CONTRACT CHANGE ORDER NO. 314S3
SHEET 2 OF 14

MARK	DATE	DESCRIPTIONS	BY	CH'D	CCO#
2	10/10/13	PIER E2 ROD TESTING	CC	MN	314S3
1	08/01/13	REMOVE AND TEST SAMPLE RODS	CC	MN	314S2
0	06/11/13	REMOVE, REPLACE, AND TEST SAMPLE RODS	CC	MN	314S1

SAN FRANCISCO OAKLAND BAY BRIDGE
EAST SPAN SEISMIC SAFETY PROJECT
SELF-ANCHORED SUSPENSION BRIDGE
(SUPERSTRUCTURE & TOWER)

LAYOUT PLAN-TEST RIG #12 (MODIFIED FROM TEST RIG #10)

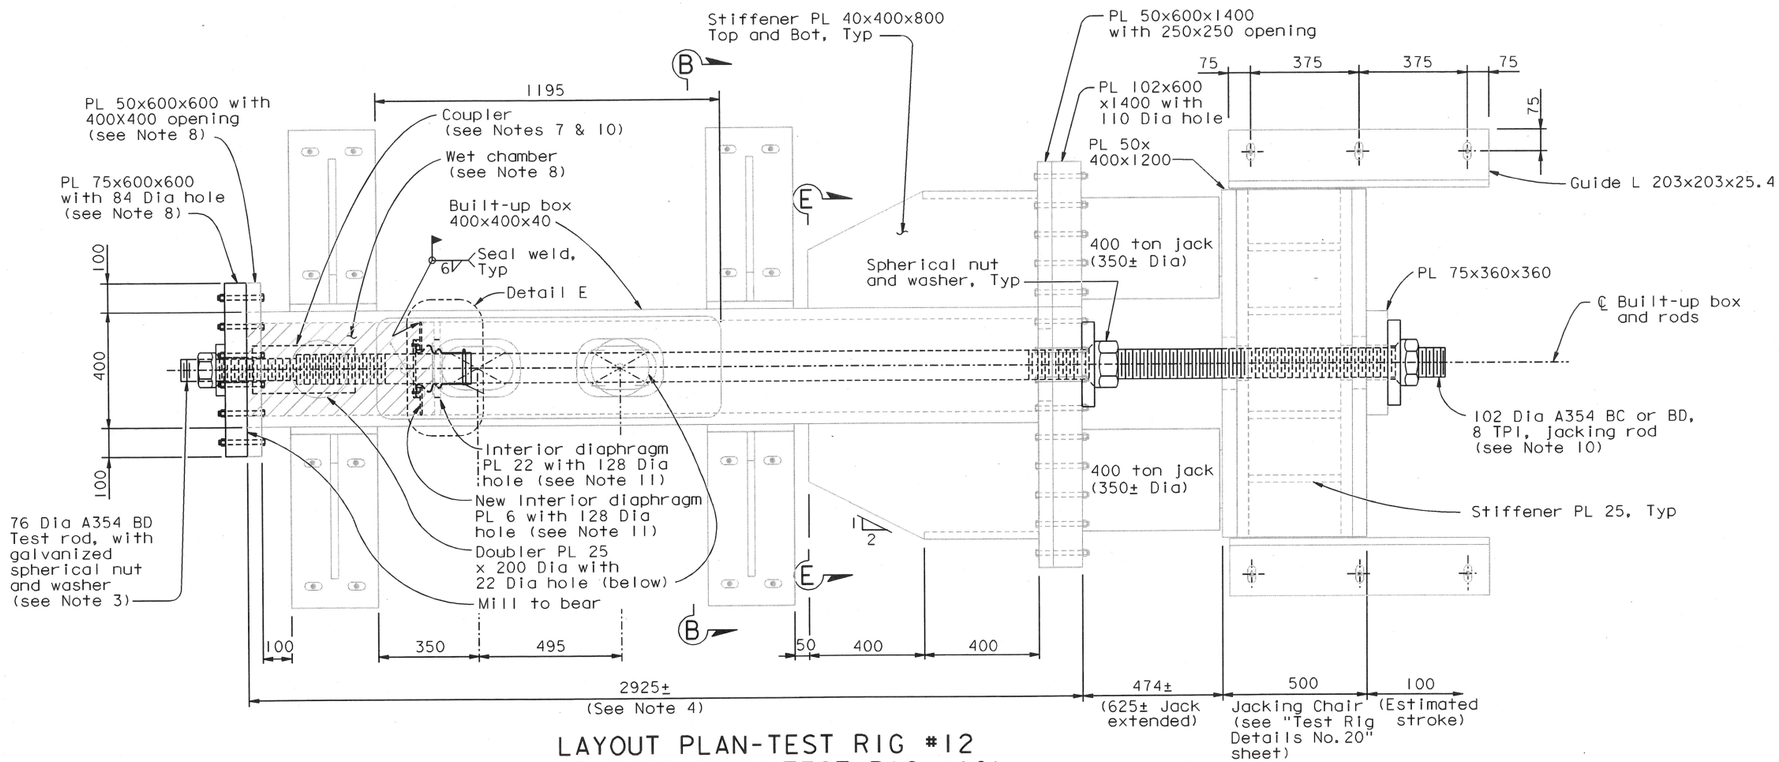
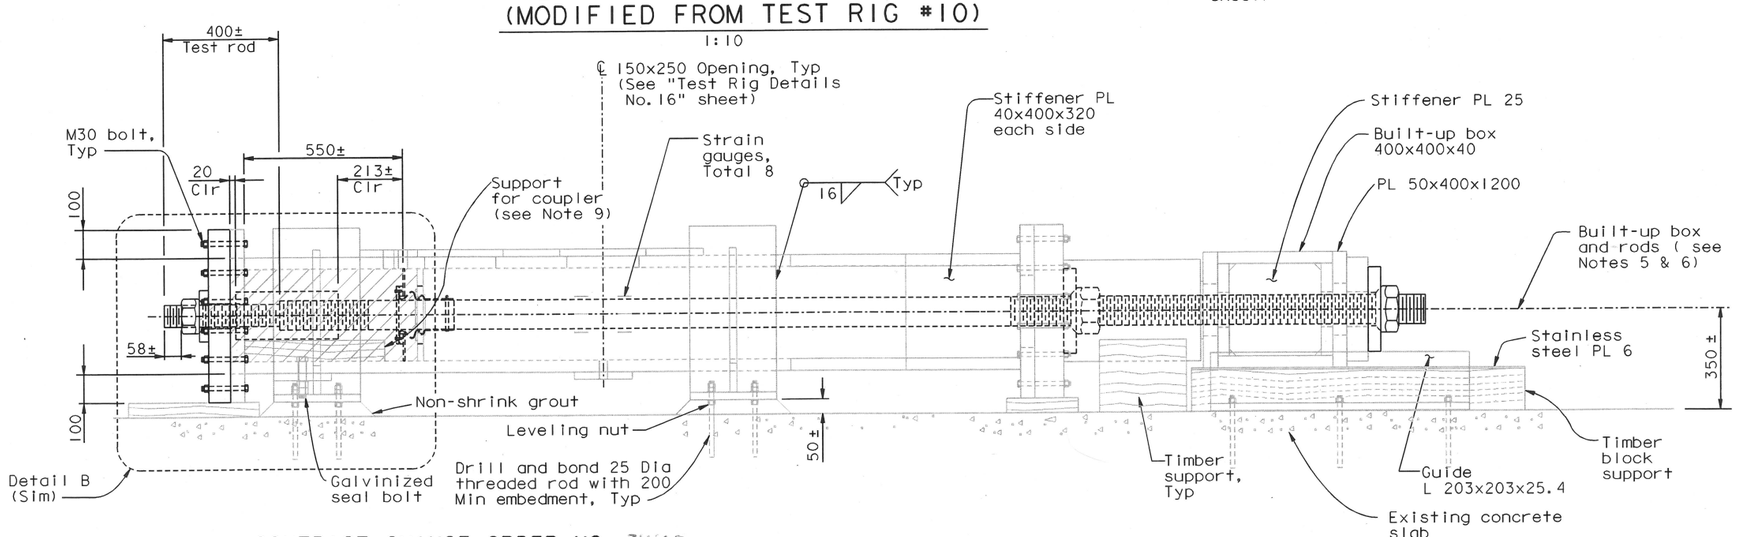
1. For pre-use inspection on existing test rigs #10 and #11 and test rig modification procedure, see "Test Rig Details No. 28" sheet.
2. For Detail B, see "Test Rig Details No. 17" sheet. For Section B-B, see "Test Rig Details No. 15" sheet. For Section E-E, see "Test Rig Details No. 18" sheet.

3. Minimum of 75 mm of threads of the rod shall be submerged in the NaCl solution at the start of the test.
4. Built-up box 400x400x40 (Test Rig #10) shall be used.

5. Test assembly shall be checked for levelness.
6. CL of built-up box and rods shall be aligned to within 4 mm.
7. For coupler detail, see Detail C on "Test Rig Details No. 28" sheet.

11. For existing interior diaphragm and new interior diaphragm, see Detail E on "Test Rig Details No. 28" sheet.
12. Structural steel Notes on "Test Rig Details No. 9" sheet apply.

TEST-RIG MODIFICATION PROCEDURE:

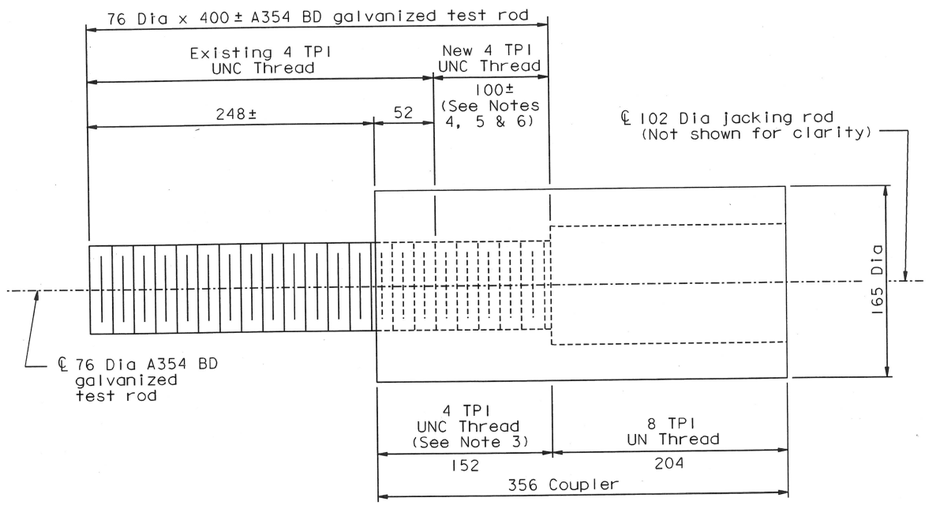
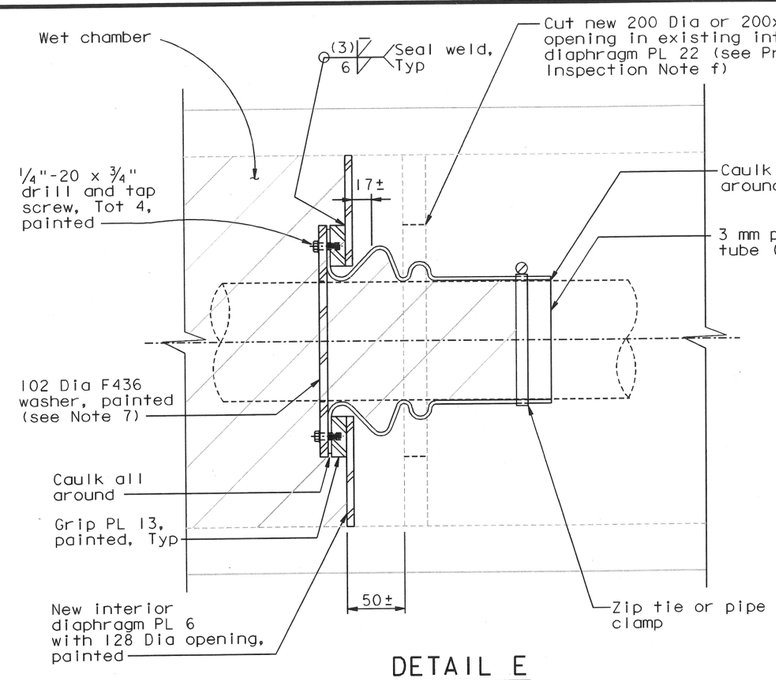
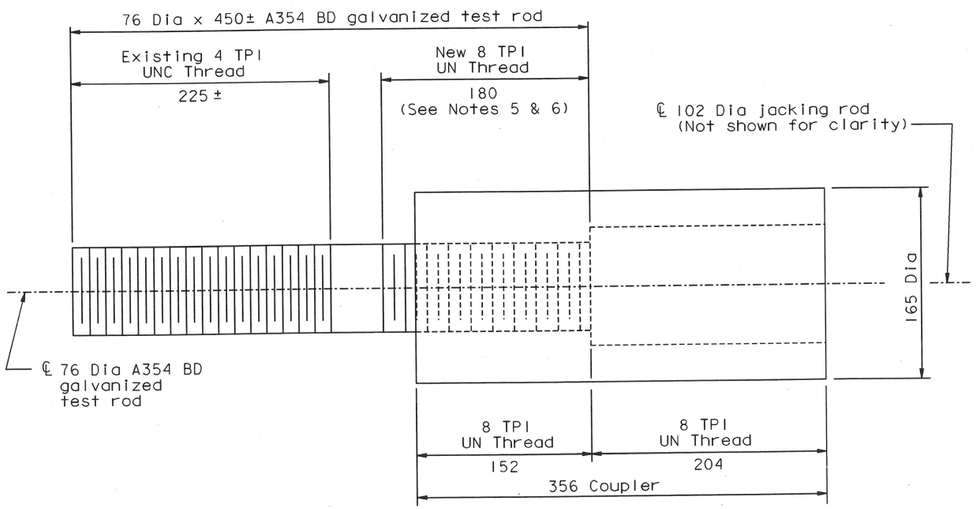
1. Cut new 200 Dia or 200x200 opening in existing damaged interior diaphragm PL 22.
2. Weld on new interior diaphragm PL 6 complete with grip PL 13.
3. Clean and remove all rust stains inside the wet chambers.
4. Repair damaged paint on all interior wetted surfaces of the wet chambers, including inside of holes. Surface preparation and application procedure shall be per manufacturer's recommendations.
5. The Contractor may sequence the above work according to his means and methods.
6. Structural steel Notes on "Test Rig Details No. 9" sheet apply.
